**CITY OF SACRAMENTO**  
1231 I Street, Sacramento, CA 95814

**Nature of Work: REROOF 52 SQ**

SCHOEN ENGINEERING

SUBJECT: Roof structural inspection at 6643 Harmon Drive, Sacramento, CA 95831

ROOF PLAN @  
6643 HARMOLD DR  
SACRAMENTO, CA

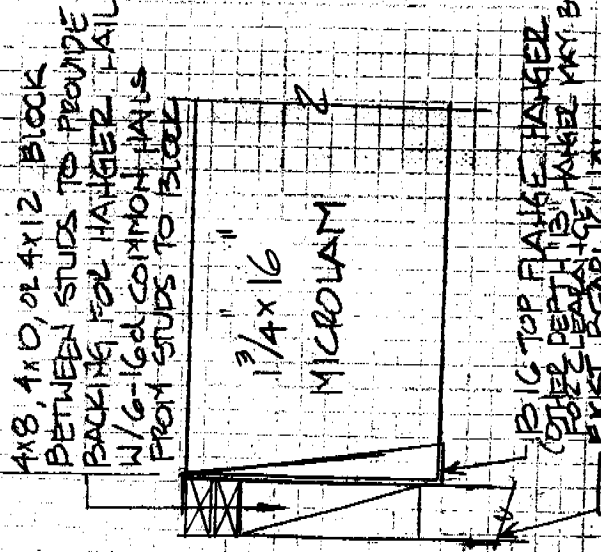
\* In the garage the ends of the ridges that intersect the short cripple hip are not properly supported by the framing. In this area install two 1-3/4"x16" Microlam beams between the front and back wall of the garage, one under each brace point and brace the ridges off of the beams(see plan and sketches for location and details).

ALONG RIDGE DOUBLE ALL EXISTING RIGID BRACES  
& ADD BRACES TO RIGID BRACES  
ALSO STRAP THE JOINTS ACROSS RIDGE

HEADER REINFORCEMENT

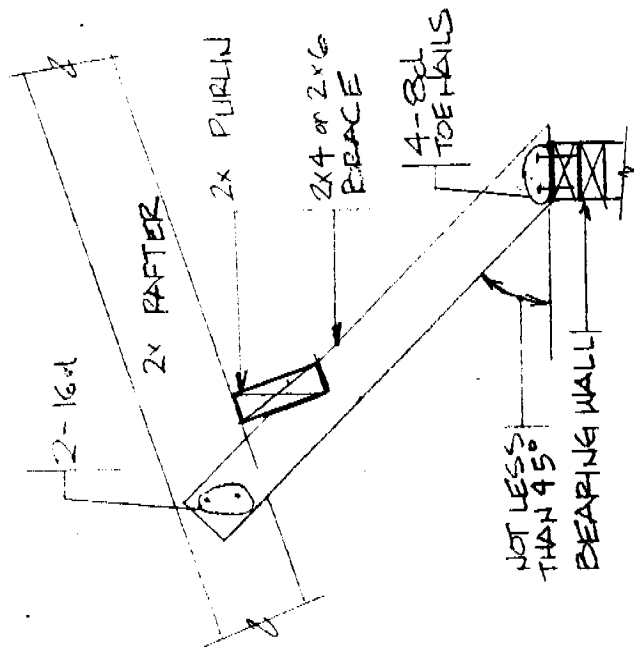
\* In the garage the existing 4x12 garage door header is not adequate to support the roof loads. Reinforce the header by installing a 1-3/4"x16" Microlam beam on the back side of the header directly against the header from king stud to king stud. Attach the Microlam to the header with 2-columns of 6-16d common nails at each end, one column into the king stud and one column into the header above the trimmer cripples, then 2-rows of 16d common nails @ 12" o.c. staggered in the field(see sketch). Also, install 2-columns of 6-16d common nails where the Microlam beam frames into the header or sit above it. The nails into the king stud should be predrilled with a 1/8" diameter drill bit.

1 3/4 x 16 MICROLAM W/2-ROWS OF 16d COMMON NAILS @ 12" O.C. FIELD, 6" 16d INTO THE KING STUD & 6" 16d INTO THE HEADER ABOVE THE TRIMMER STUDS (NAILS INTO KINGSTUD SHOULD BE PREDRILLED 1/16" & DEEP BIT)

NOTE: IF THERE ARE CRIPPLE STUDS ABOVE HEADER @ 16" O.C. 2-16d COM. NAILS INTO EA STUD MAY BE SUBSTITUTED FOR BOTTOM ROW OF NAILS

NOTE: IF THE MICROLAM BEAM IS SUPPORTING THE RIDGES IS SUPPORTED AT THE WALLS WITH A TOP FLAKE HANGER, THE MICROLAM BEHINDING THE HEADER SHOULD BE HEUD FLUSH WITH THE TOP OF THE TOP PLATE. IF NOT IT MAY BE MOVED UP OR DOWN TO ALLOW FOR HARDWARE OR BRACING.

NOTCHED PURLIN BRACE

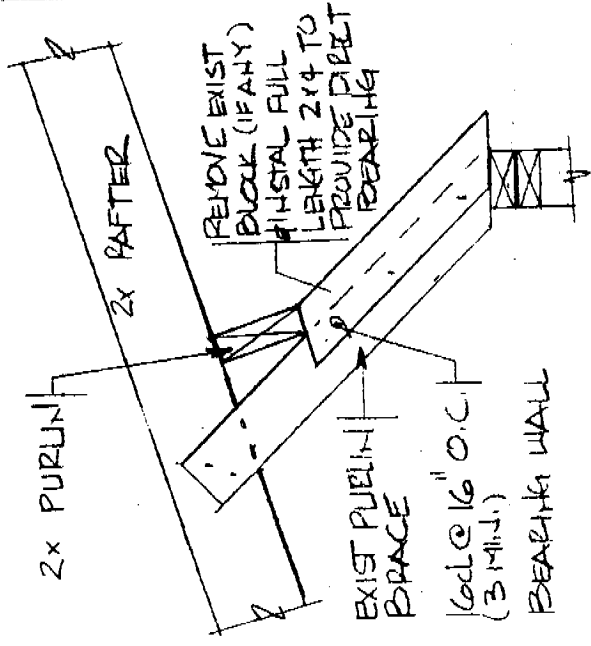
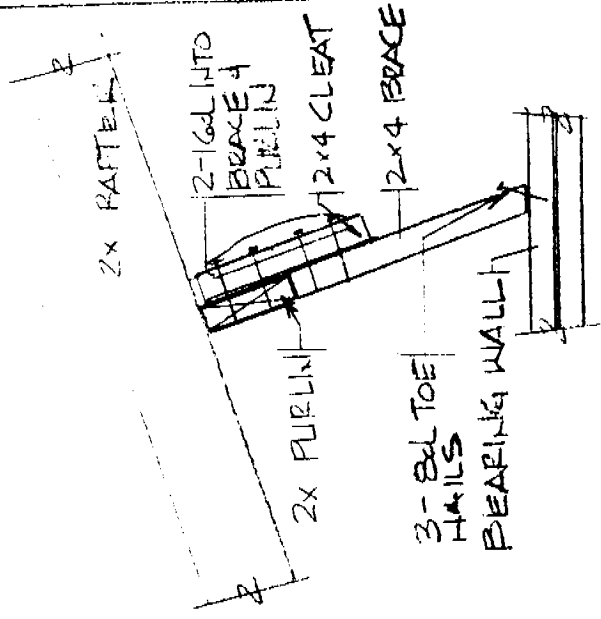
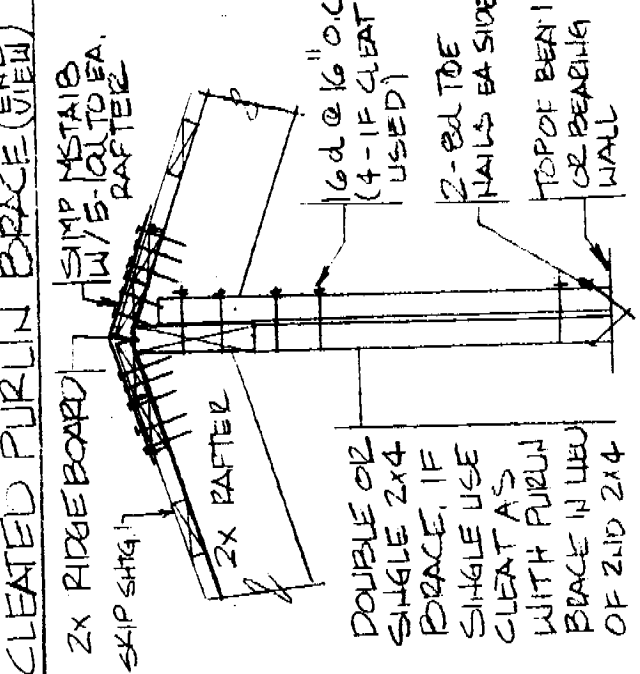
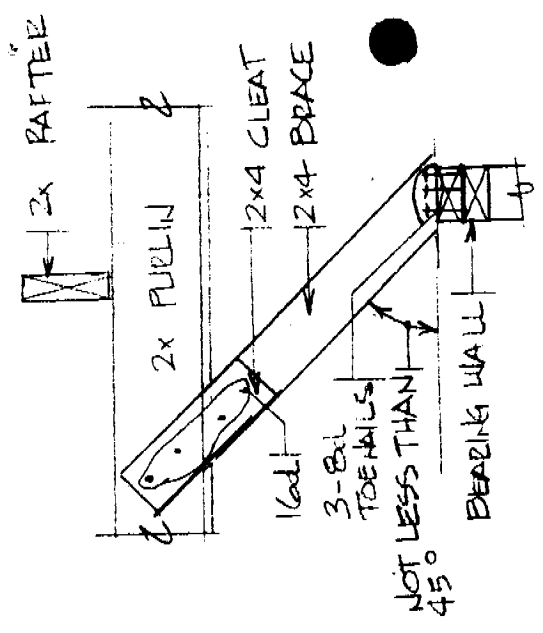
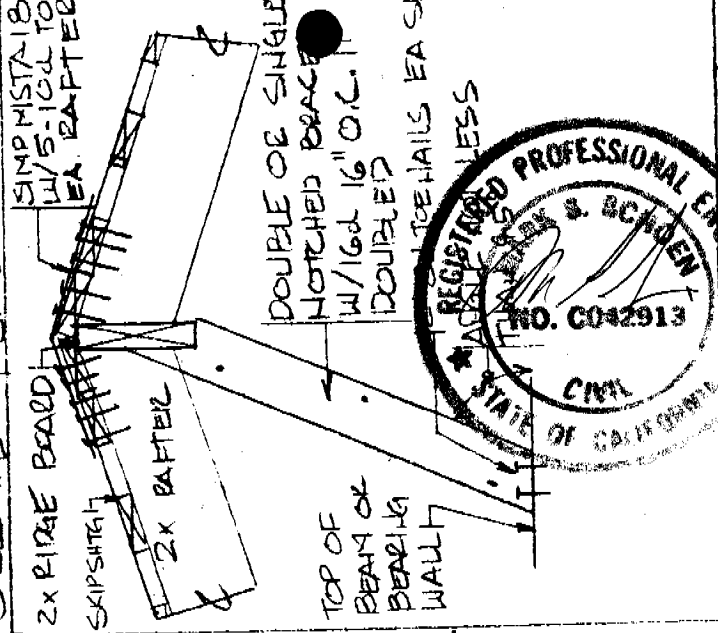
\* Some of the purlin braces in the attic areas of the house are framed so as to run by the purlin and then rely on nailing and a 2x4 block nailed to the brace underneath to support the purlin. These are not adequate to support the proposed roof loads and should be redone. These braces should either be replaced by braces providing direct bearing for the supported member or modified to provide direct bearing. Also, the existing ridge braces for the supported ridge of the house should be doubled and additional braces added to reduce the ridge board span to no more than 8'(see sketch for bracing details).

EXISTING BRACE MODIFIED FOR DIRECT BEARING

NOTE: BRACE MAY LEAN IN LINE W/ RIDGE BUT @ ANGLE NOT FLATTER THAN 45°
